NEW YORK STATE THRUWAY AUTHORITY
DEPARTMENT OF ENGINEERING

AMENDMENT NO. 1
TO

CONTRACT TAB 24-23
D214981
1R MILL AND INLAY BETWEEN
MP 430.6 AND MP 438.5
IN THE BUFFALO DIVISION
OF THE NEW YORK STATE THRUWAY
IN ERIE COUNTY

IN THE LETTING OF
JUNE 12, 2024

TITLE:
STRUCTURES TABLE BRIDGE INFO

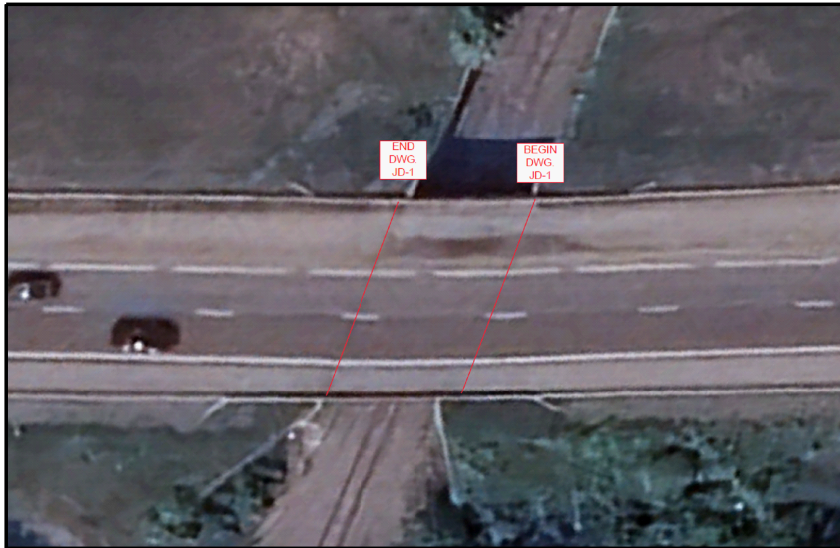
1. **DELETE** Page 19, DWG. NO. ST-BI and **REPLACE** with the attached Page **19-A1**, DWG. NO. ST-BI. The Mainline Bridge Information at Milepost 430.84, Abbot Rd., Milepost 434.31, Southwestern Boulevard WB, and Milepost 434.32, Southwestern Boulevard EB have each been updated. Milling and Inlaying is not required at these locations.
2. **ADD** the attached pages **74A-A1** and **74B-A1** to the Special Specifications section of the Proposal. The special specification for Item 646.46 25, Removable Yellow Thermoplastic Flexible Delineator Assembly is now available.

#	MP	BIN	NAME	MILL AND INALY SECTION	JD-1 SAW & SEAL	Approx. Overlay Thickness
1	430.84	5512149	Abbot Rd.	NA		PCC
2	431.49	5511750	South Branch Smokes Creek	SECTION B	240'	5"
3	434.31	5015471	Southwestern Blvd. WB	NA		PCC
4	434.32	5015472	Southwestern Blvd. EB	NA		PCC
5	434.48	5512482	RR	SECTION B	112'	3"
6	434.49	5512481	RR	SECTION B	112'	3"
7	436.22	5512460	Interchange 57	SECTION A	172'	2.5"
